# Service Bulletin 32

(a) Service Bulletin No:	32
(b) Revision / Date	4 / 03 November 2021
(c) Title:	Quick Shut Off Valves on Duplex propane cylinders CB2901, CB2902, CB2903.

(d) Description:	<p>Undersize CB437 flanged adaptors for Quick Shut-Off valves.</p> <p>Stainless Steel Cylinders CB426, CB497, CB599, CB959, CB2088, V20, V30, V40; Titanium cylinders CB2380, CB2383, CB2385, CB2387, T30 (CY-050-A-001 and "Worthington" Aluminium Cylinders CB250 may also be affected if fitted with CB437 flanged adaptors supplied on invoice numbers listed in section (f)</p>

SB32 Cylinder Torque Test  
& Rectification Action

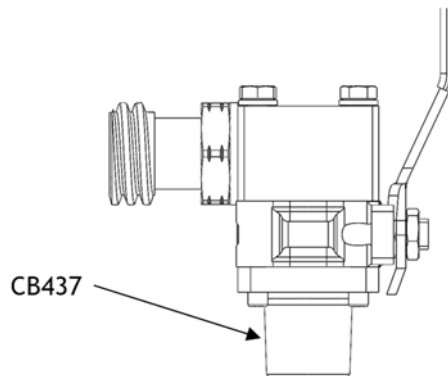
Two batches of CB437 Flanged Adaptors for Quick Shut-Off (QSO) valves have been supplied with undersized threads.

When the minimum sized adaptors are combined with cylinder bosses at maximum tolerance dimension the thread can bottom out in the cylinder boss. Although the required installation torque values can be achieved the unscrewing torque may be undesirably low. In extreme cases the adaptor may be unscrewed by hand.

Affected cylinders are prohibited from further flight.

Affected cylinders must be checked for leaking around the interface between the QSO valve Flanged Adaptor and the cylinder boss using leak detector fluid within 24 hours of receipt of this bulletin. Any cylinders found to be leaking should be emptied of fuel immediately. A pilot may carry out this inspection. A satisfactory leak check **does not** release the cylinder to service.

Final rectification action must be applied to all affected cylinders before 31/01/2022. Rectification action requires the replacement of the Flanged Adaptor with either a CB437 adaptor at Issue H or later, or by replacing the QSO valve assembly with a handwheel valve part No CB0824-0001 (this part has a Rego-type hose connection).

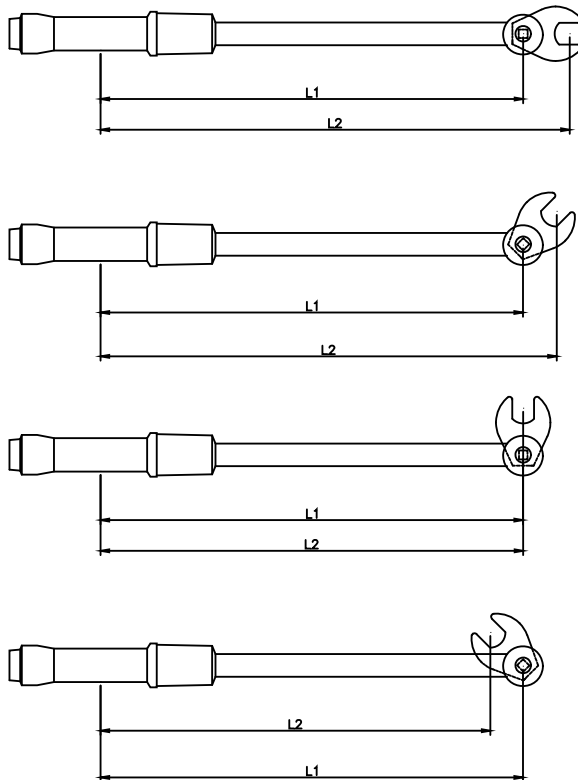
When you put an adaptor on a torque wrench (e.g. a 'Crow's Foot') that extends its length the torque applied to the fastener increases as the lever arm extends. This calculation will work out what value you should set into the wrench to achieve the required fastener torque.

The following formula has is used:

$$M1 = M2 \times L1 / L2$$

Note that when the 'Crow's Foot' is at 90° to the torque wrench  $L1 = L2$ , so no correction factor is required.
